MILITARY SPECIFICATION

MODULES, STANDARD ELECTRONIC

INVERTER, DIGITAL, KEY CODE RBG

This amendment forms a part of Military Specification MIL-M-28787/82A(EC), dated 18 January 1980, and is approved for use by the Naval Electronic Systems Command, Department of the Navy, and is available for use by all Departments and Agencies of the Department of Defense.

FIGURE 6. V_{OUT} (low-loaded) test circuit for table IV.

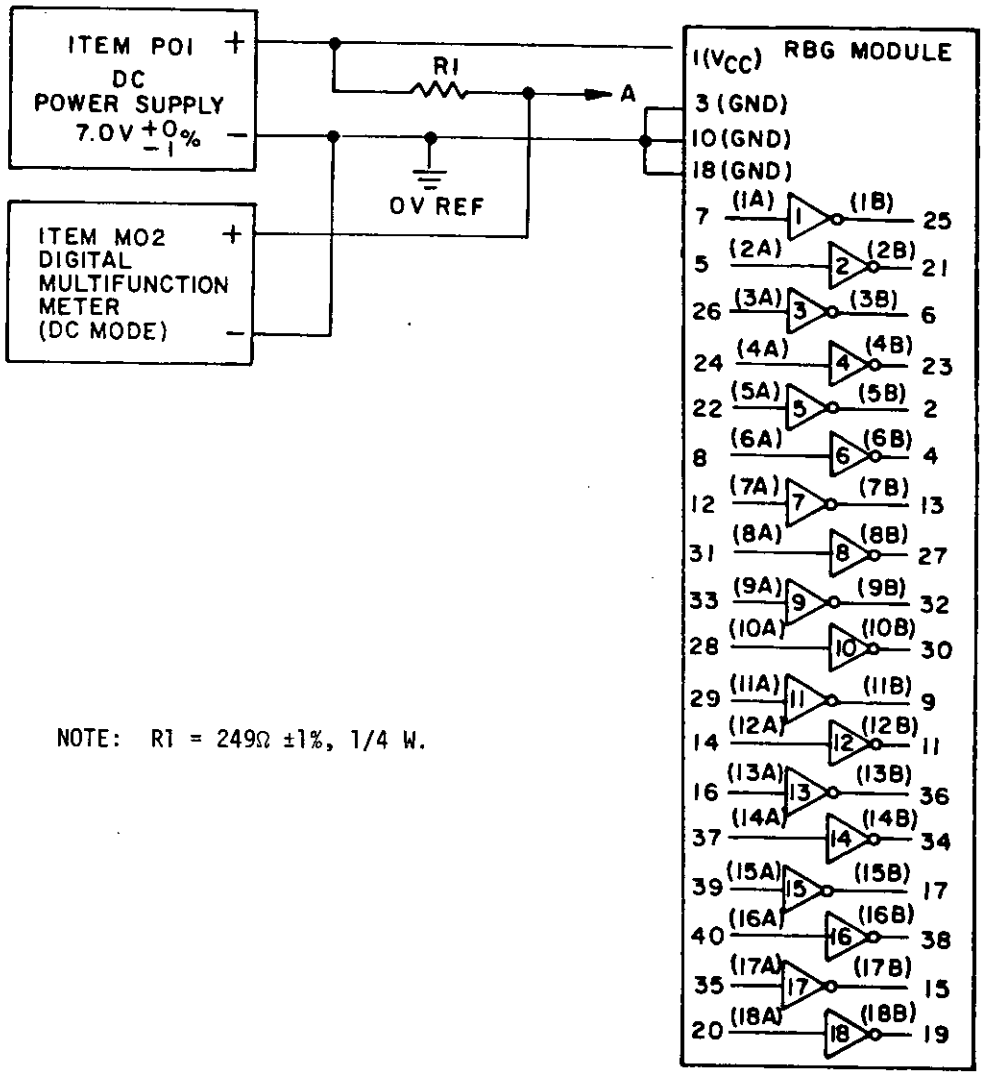
FIGURE 6: Delete and substitute new figure 6 as printed on page 2 of this amendment.

NOTE: R1 = 249Ω ±1%, 1/4 W.

FIGURE 10. Input clamp diode voltage test circuit for table VIII.

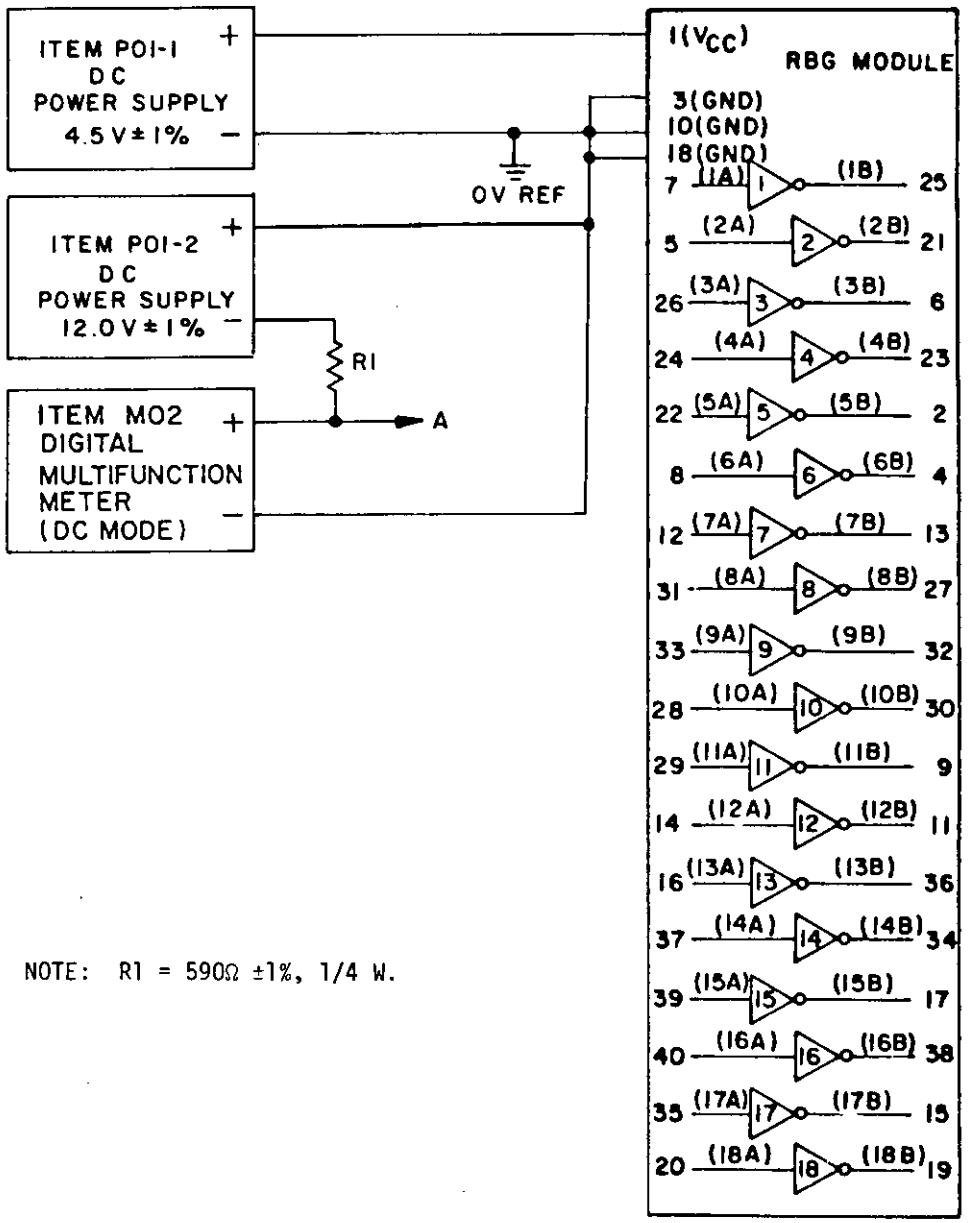
FIGURE 10: Delete and substitute new figure 10 as printed on page 3 of this amendment.

NOTE: R1 = 590Ω ±1%, 1/4 W.

FIGURE 11. Static output voltage (low-level and high-level) test circuit for tables IX and X.

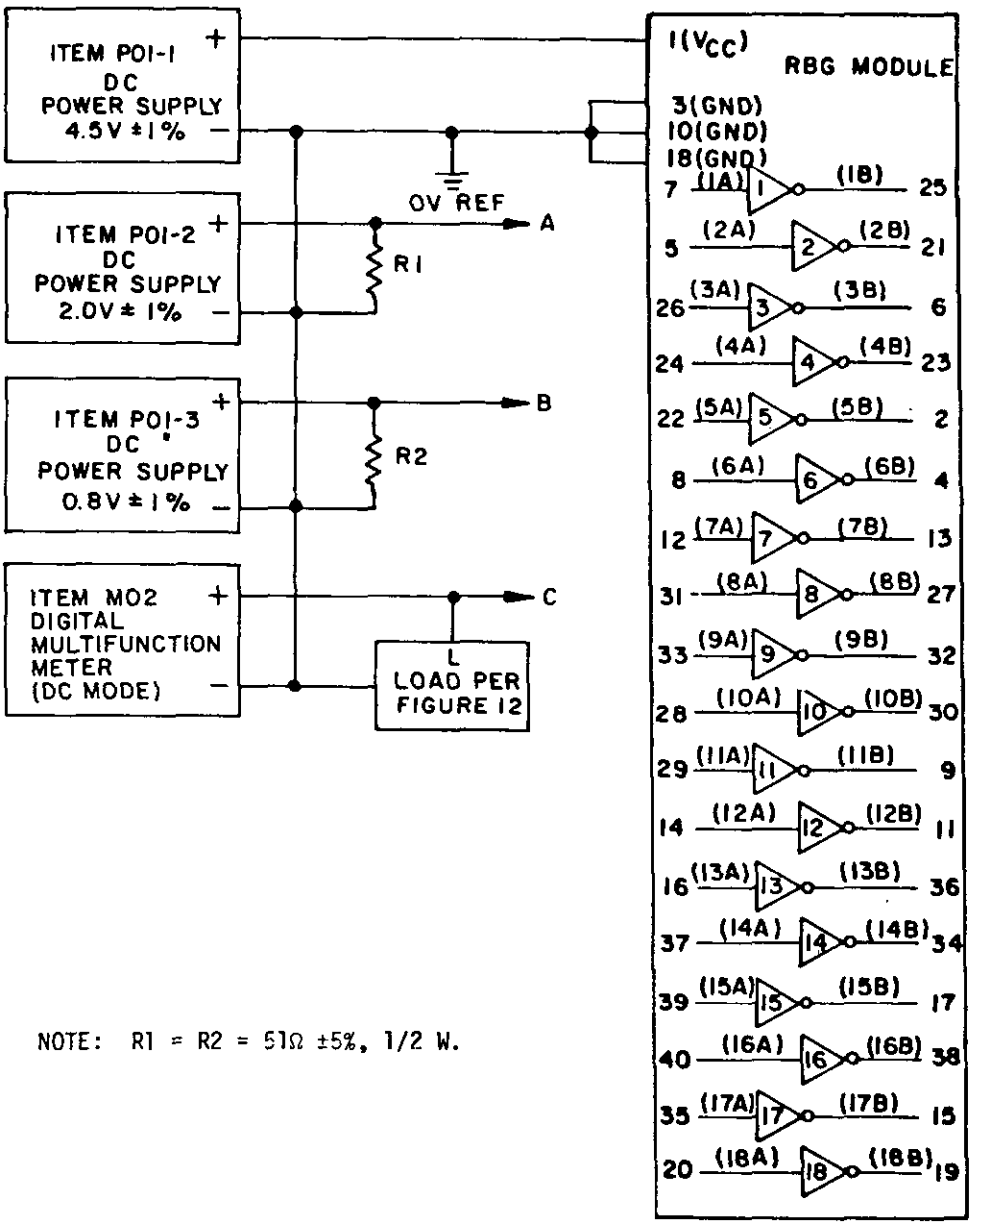
FIGURE 11: Delete and substitute new figure 11 as printed on page 4 of this amendment.

NOTE: R1 = R2 = 51Ω ±5%, 1/2 W.
